**SECTION 00 9116**  
**ADDENDUM NUMBER 6**

**DATE: August 17, 2016**

**RSMP Phase 2A**  
**James Monroe High School**  
**RFI LOG**  
8/17/16

PROJECT: RSMP - JAMES MONROE HIGH SCHOOL PHASE 2A				
DRAWING TITLE: <b>STAIR 12A DOOR TO ROOF</b>				
PROJECT NO: 1522	DRAWN BY: ME	SCALE: AS NOTED	ISSUE DATE: 8/15/16	REVISION DATE: 8/15/16

**1** PARTIAL FOURTH FLOOR DEMOLITION PLAN  
 D103 SCALE: 1/8" = 1'-0"

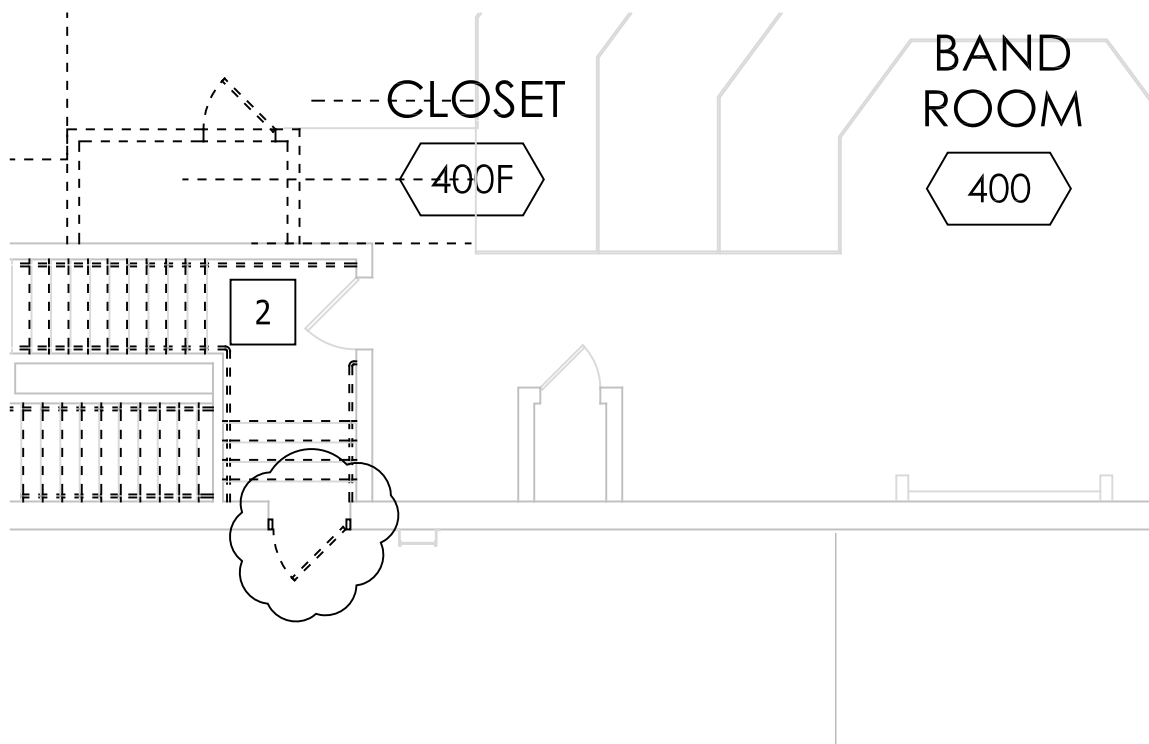
- A. Remove door and frame complete from fourth floor Stair 12A access to main building roof. See attached sketch ADDSK-A-12.
